HGY/2026/0720 - Boundary treatment changes Revised 3/7/2026 to timber fencing above the brick fence for a lighter weight trellis

Further to my objection dated 9/7/2026 to the 3/7/2026 revised changes to the boundary treatment of 2 Hampstead Lane I would like to add additional information concerning the revised drawings 2-4, 08, 09 and 11A.

2-4 “EXISTING”

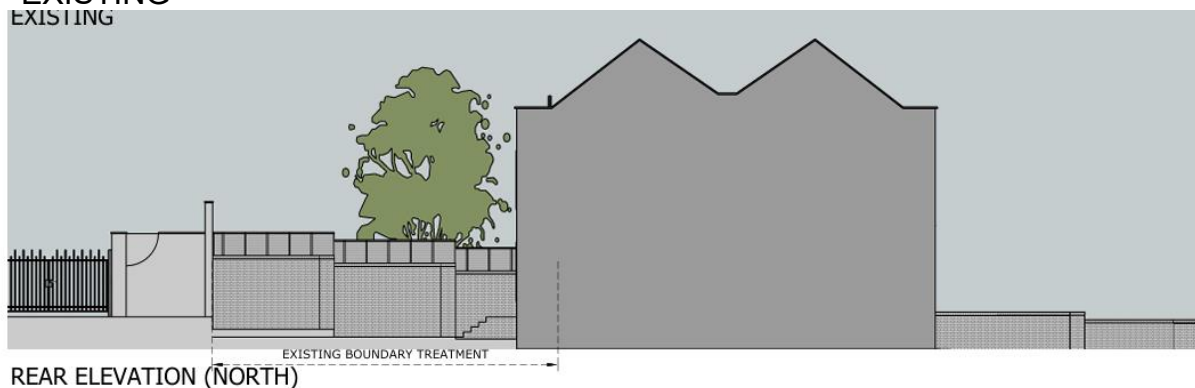
1. The applicants drawing 2-4 “EXISTING” REAR ELEVATION NORTH

This is a hypothetical cartoon drawn to support the application.

This view does not exist in reality, firstly, as the wall between 1 North Road and 2 Hampstead Lane is ~4-5metres high obscuring this hypothetical view (Rear ELEVATION NORTH), secondly this wall provides a buttress between the 1 North Road ground level and the 2 Hampstead Lane ground level ~3-5metres below. In my opinion it is misleading to include a view which fails to give the planning department the contrasting ground levels and thus the whole picture.

Please see attached a sketch of the reality with ~3-5 metre ground level changes between these properties (Existing rear elevation with drawing of the ground levels between 1 North Road and 2 Hampstead Lane).
